# Access Compliance Report

## Public Rights-of-Way

### (Pedestrian Signals)

Intersection ID: N/A	Main Street:	Cross Street: N/A	Location: N/A
ADA ID: 13A1B62F8648	Signal Type: One Push Button-APS	Overall Compliance: No	Severity Score: BTN 1: N/A BTN 2: N/A No BTN: N/A
Codes/Mitigation Info/Possible Solution		Field Measurements/Component Compliance

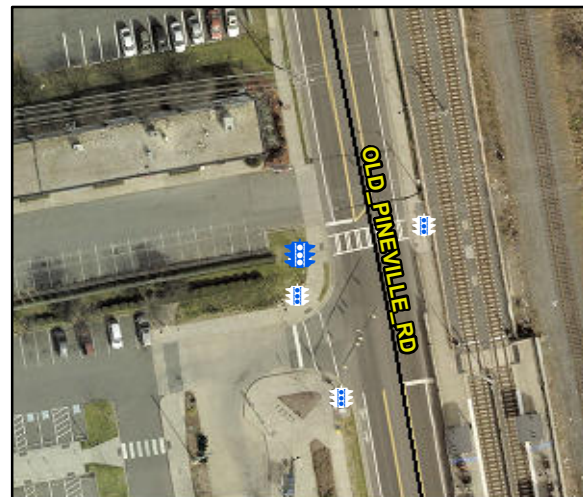
PROW/ADA: TMUTCD 4e.08, R404.3, R404.2, R404.7.3, R209.1, MUTCD 4e.10,

Yes B 1 Clear Xing Direction?	ClearlyMarked	N/A B 2 Clear Xing Direction?	N/A
B 1 Crossing Direction	To NE	B 2 Crossing Direction	N/A
Yes B 1 DistanceTo XWalk (in)	0.0	N/A B 2 DistanceTo XWalk (in)	N/A
No B 1 DistanceTo Curb (in)	126.0	N/A B 2 DistanceTo Curb (in)	N/A
Yes B 1 Diameter (in)	2.0	N/A B 2 Diameter (in)	N/A

Possible Solutions: Replace Signal Push Button With APS Button on New Post. Remove & Relocate Sign.
